Title: 4T2R Layout Review(AFE79XX)

Date: 08/14/2020

Texas Instruments

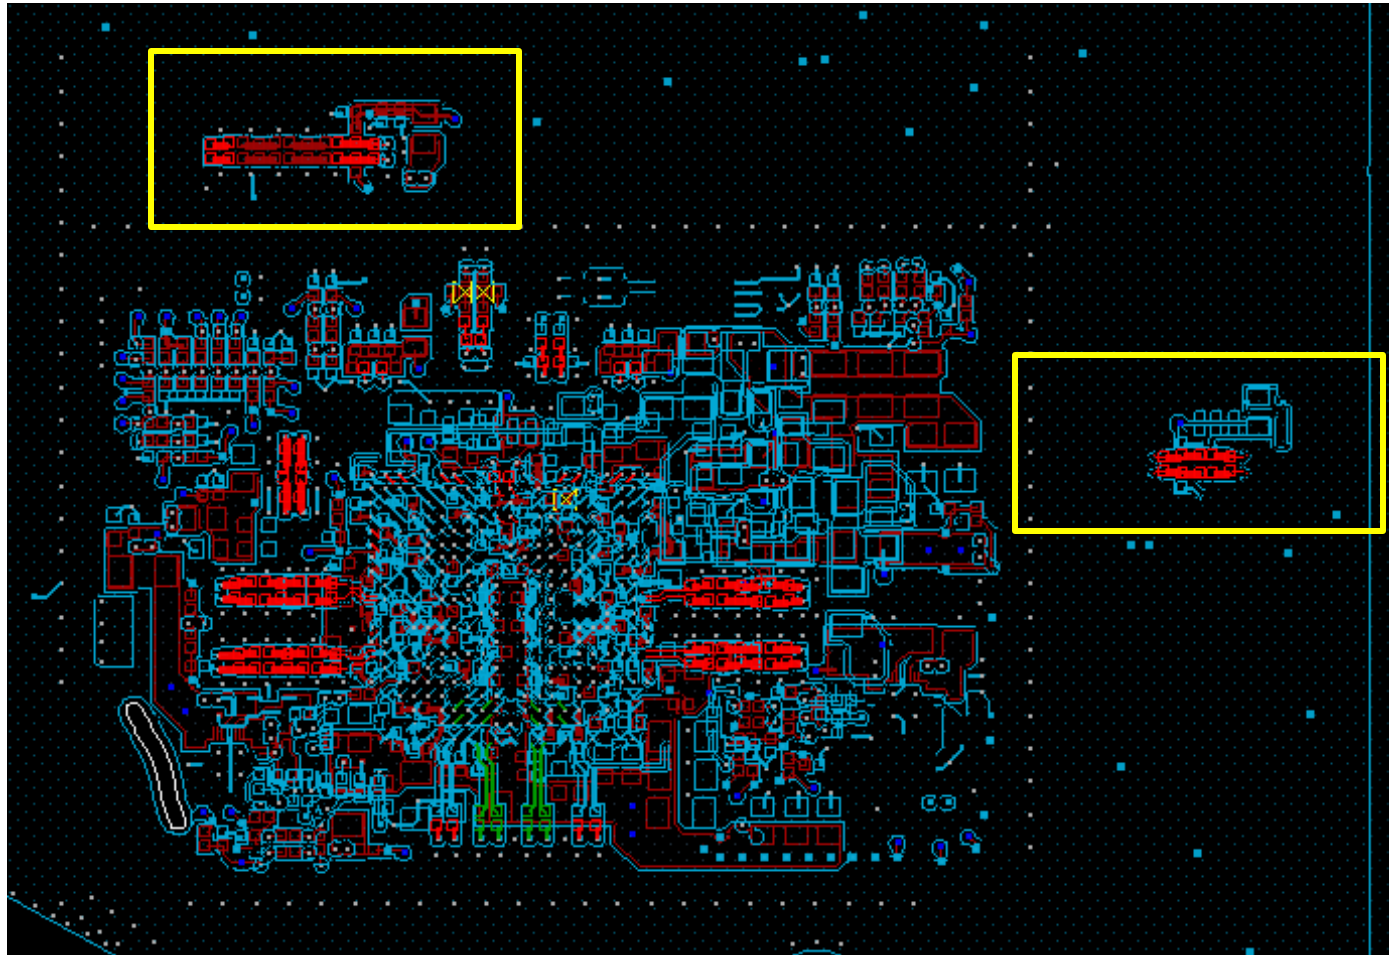
Both RX and Serdes lanes to be routed 100 Ohm differential. The trace widths are different. Ensure that impedance is 100 Ohm Diff.

The first matching element for TX is significantly far from the balls. Suggest to move the matching components near the device.

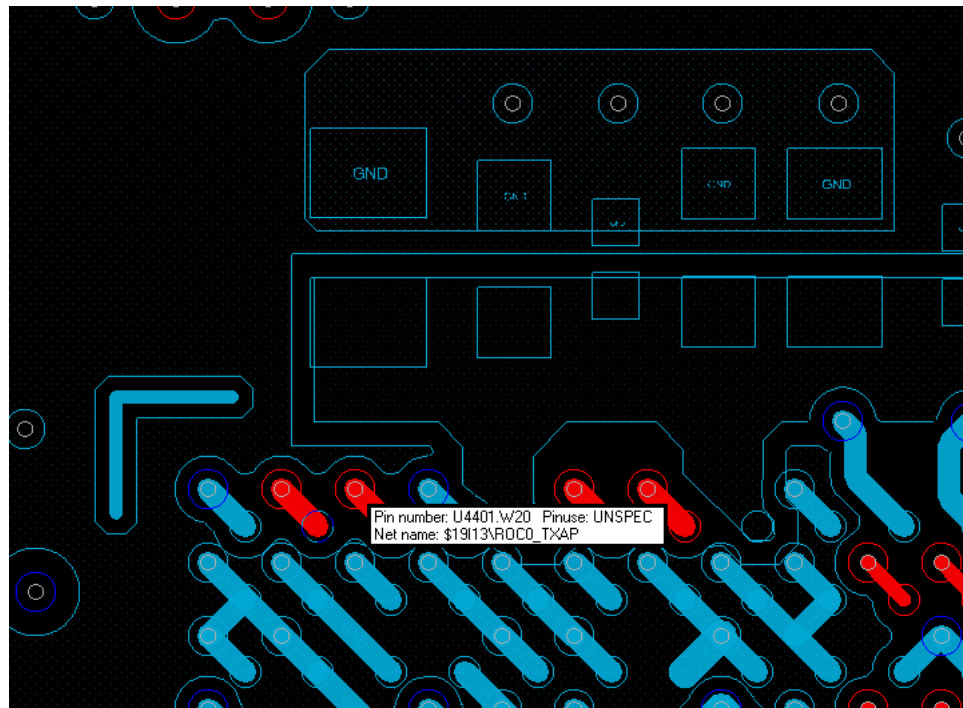
TXA and TXB balls are swapped. TXA is close to reference clock. In 2T mode TXB and TXD are supposed to be used.

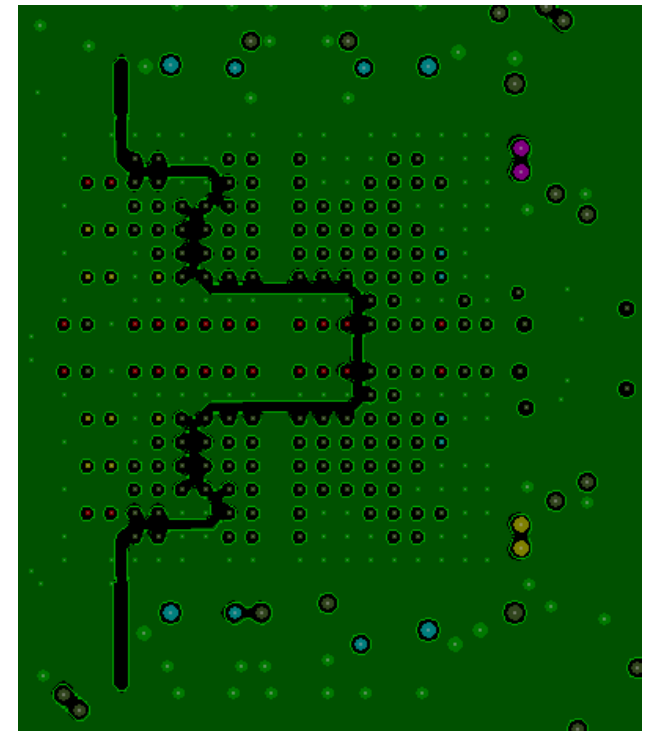
Add ground slotting to reduce the coupling from digital to RF

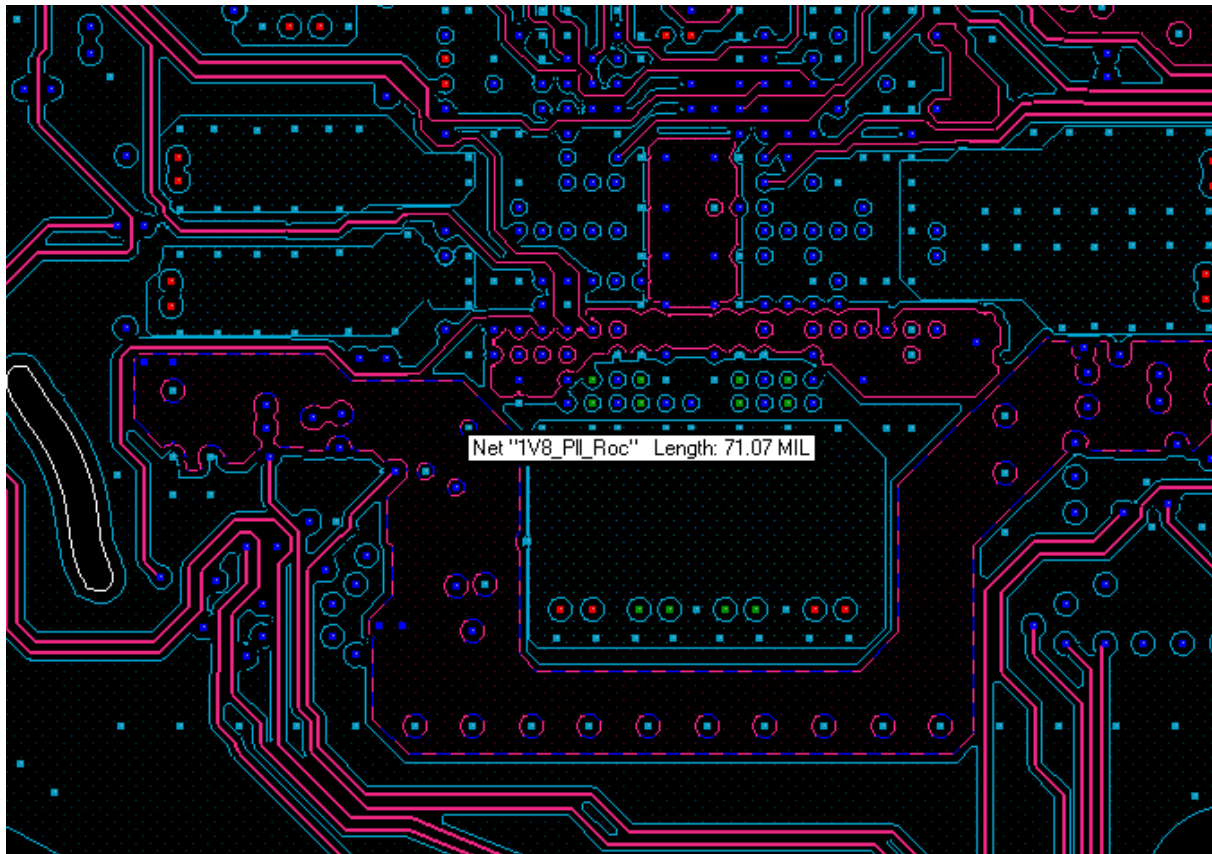
PLL supply is routed close to serdes lane routing and overlaps serdes balls(supply/gnd) (VDDA/VDDT and VSST)

Supplies VDD1p2, VDD1p8RX, VDD1p8FB and VDD1p8CLK have overlap with digital supply/gnd balls. Avoid overlap of digital power/gnd and analog power/gnd
